SUBJECT: Oral Report by Bell Telephone
Laboratories on the Addition
of 4-Wire Circuits To The
Operational Intercommunication
System at KSC
Case 320

DATE: May 15, 1967

FROM: J. J. Hibbert
G. H. Speake

MEMORANDUM FOR FILE

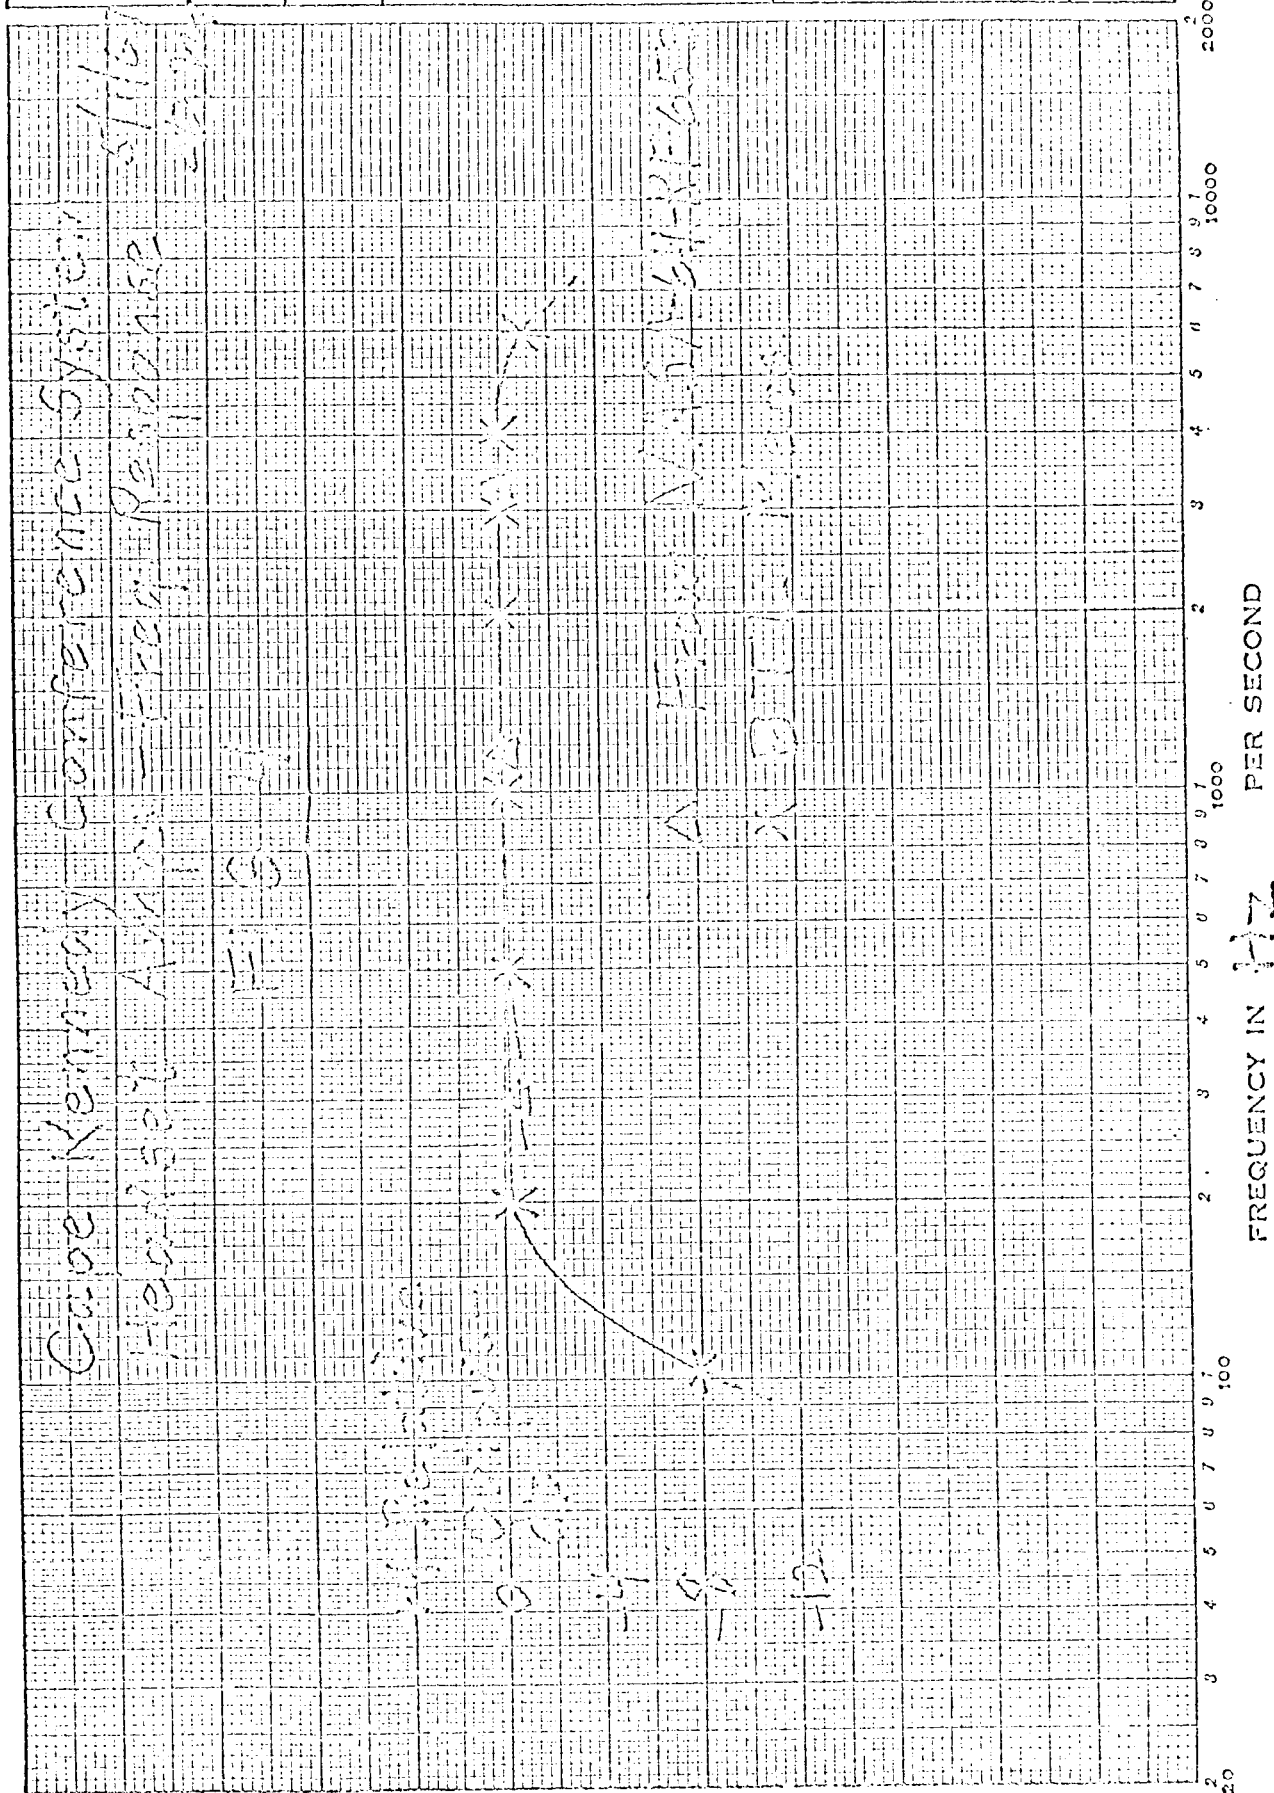
Figure 3 shows the input-output characteristics of the two amplifiers. In this case the measurement on the present amplifier was made with the output connected into 600 ohms, but the measurement on the GE amplifier was made with the output connected into 60 ohms. Our measurements indicated considerably less expansion at low inputs than is stated in NASA-64-KF-652. There is no apparent reason for this difference, but possibly the NASA measurements were made on a different version of the microphone amplifier.

The limiting in the microphone amplifier measured occurs at approximately the same point as shown in NASA-64-KF-652. It was found, however, that the limiting action for high inputs such as 10^{-3} volts required about 80 ms.* There is very little gain decrease for the first 50 ms, and most occurs during the next 30 ms. It was also noted that for inputs greater than 5×10^{-4} volts the output signal would be distorted during the first 40 to 50 ms. This distortion is due to overload in the amplifier and occurs before the AGC circuit can operate.

The recovery time is about 300 to 500 ms after a strong signal is removed. These time constants are reasonably satisfactory, but not ideal. It would be better if the attack time would be about 10 ms, but the recovery time is satisfactory.

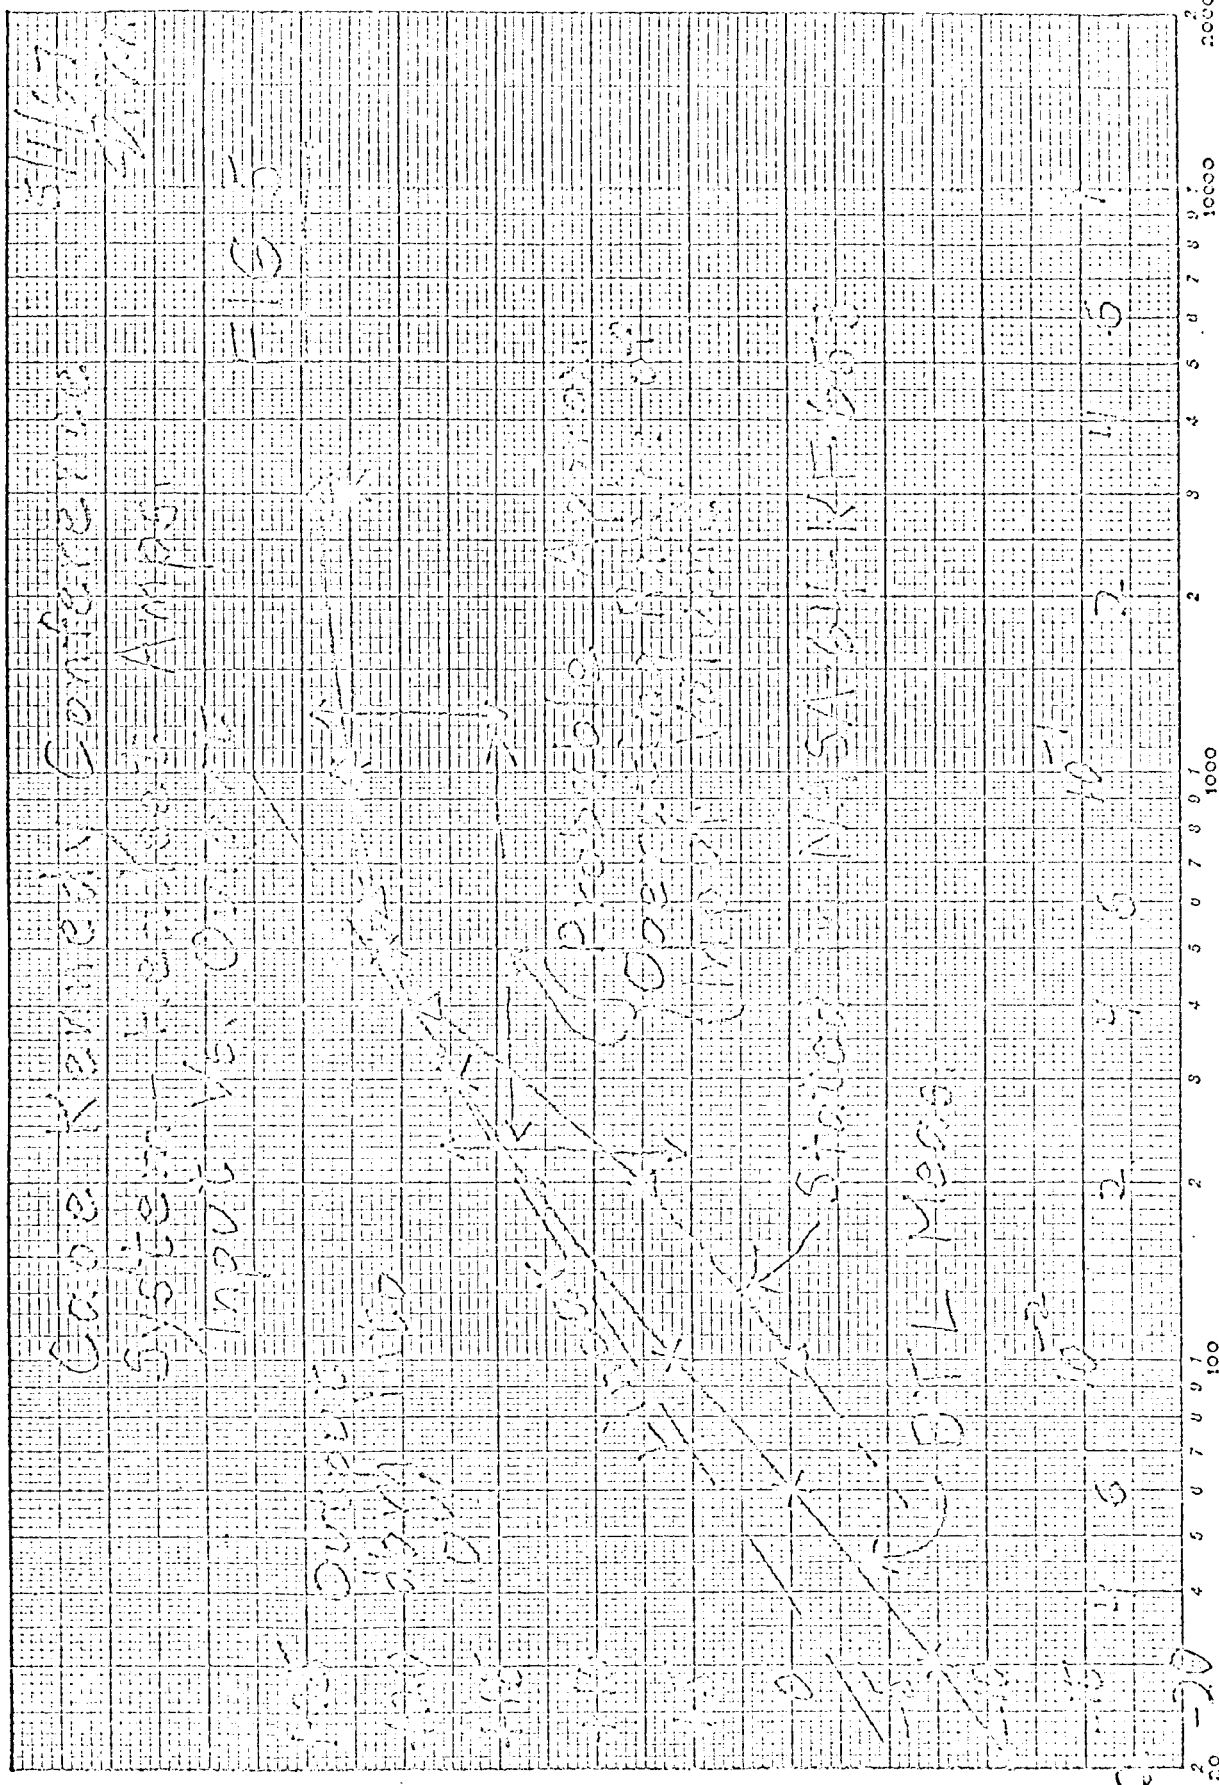
Figure 4 shows the frequency response of the headset amplifier. Here our measured results are very close to NASA-64-KF-653. On the other hand it would be very desirable for this amplifier to roll off below 300 cycles and above 3000 cycles. Energy below 300 cycles may contain undesirable 60 cycle harmonics and does not add to intelligibility. Energy above 3000 cycles also adds very little to intelligibility and may contain high frequency noise.

FIGURE 2

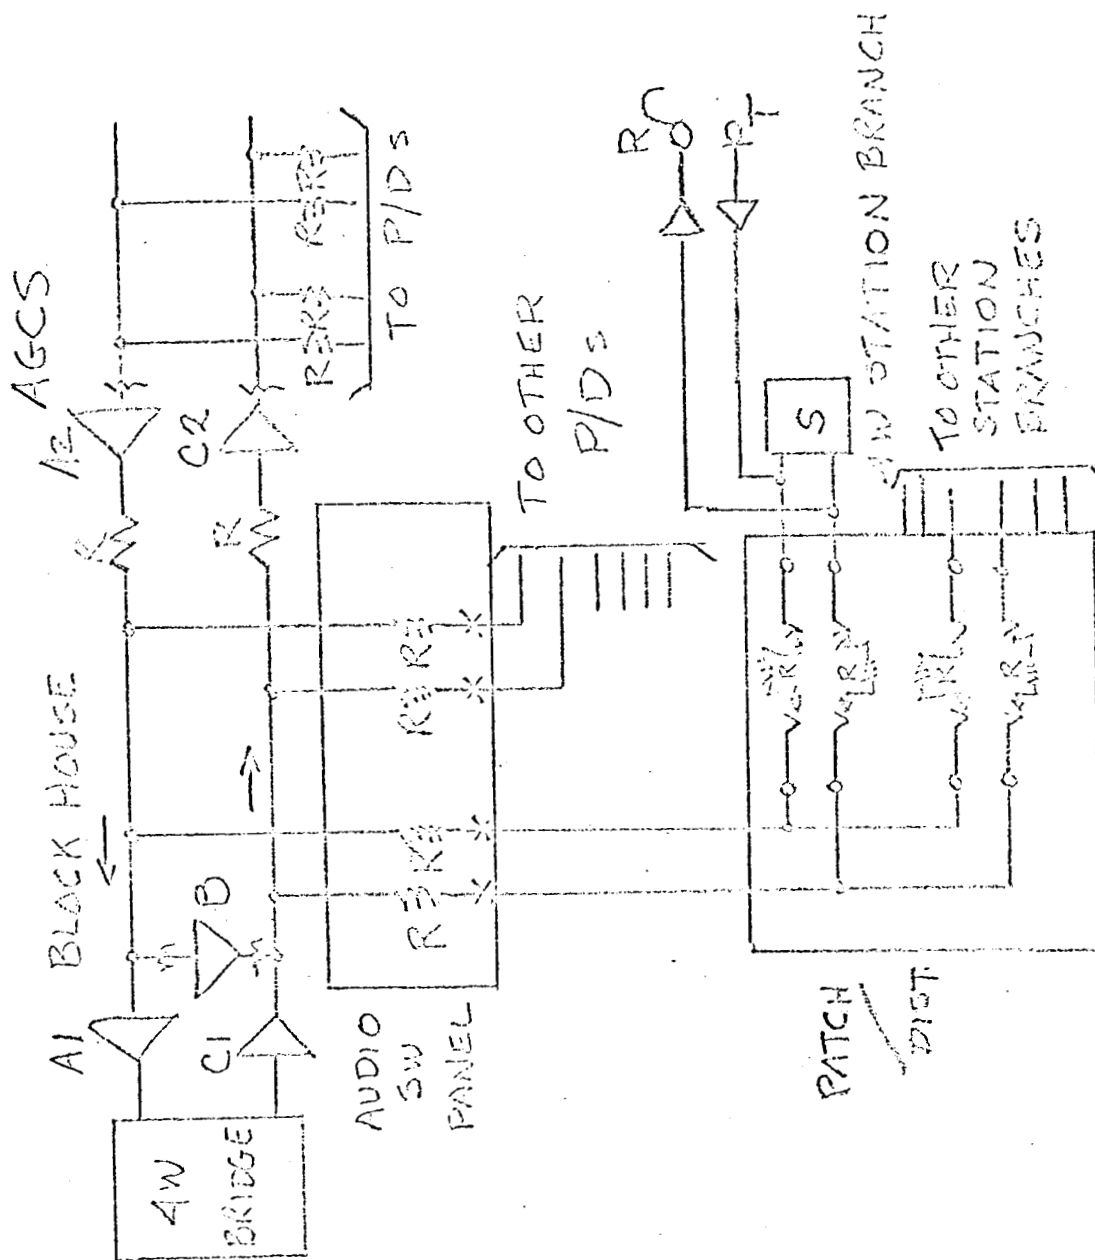
A general plan and manner of cabling for the critical conference circuits is illustrated on Figure 2. There are several features in the plan:

It is not yet known whether the present A1A amplifiers have adequate power to operate with the low impedances required for use with the conference busbar. The bus amplifier B is arranged to operate with both 1 ohm input and output impedances. This amplifier provides the talk-back path from any station to all the other stations connected to the busbar. It also furnishes the sidetone path for every talking station. The receiving amplifier of every station is connected through isolating resistors to the receiving busbar. Similarly the transmitting amplifier of every station is connected through isolating resistors to the transmitting busbar. Conversations are

STATION TERMINAL ADDITION

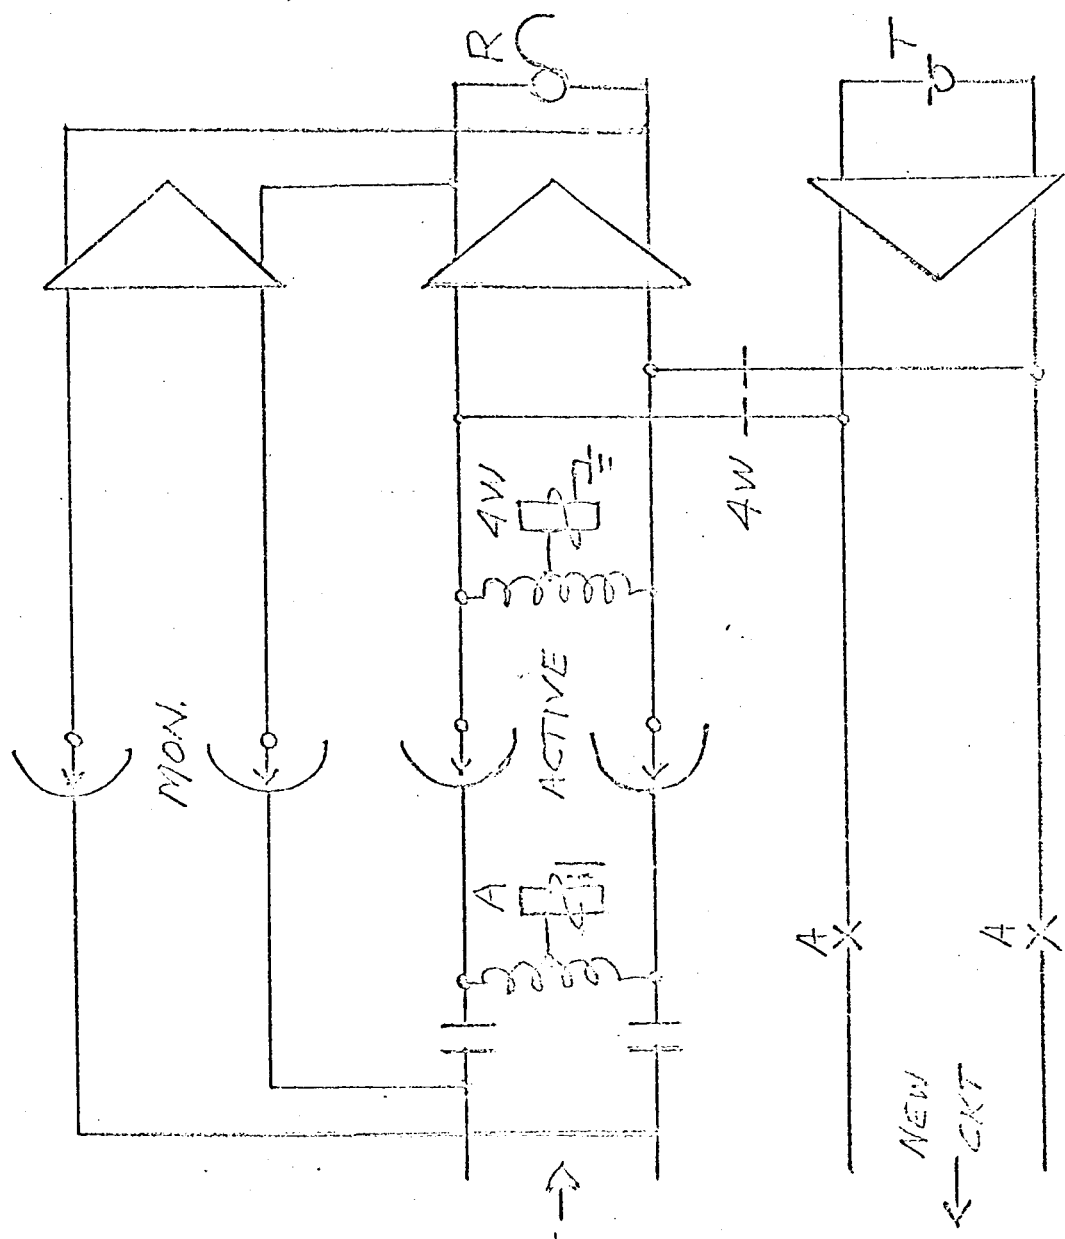
Figure 3 illustrates a way in which the station circuit could be modified to accommodate both 2- and 4-wire operation. It should be understood that the workability of the illustrated plan will depend upon many factors, including shock, vibration, cable leakage, cable pair balance, earth potential and other factors which may come to light later. The additions needed include 2 retard coils, 2 relays and 2 capacitors for the first 4-wire conference circuit. These are connected on the receive leg as indicated. As mentioned earlier, the present 2-wire conference leads are used for the receive leg of the 4-wire conference. One of the other 2-wire conference circuits would be employed for the transmit leg of the 4-wire conference.
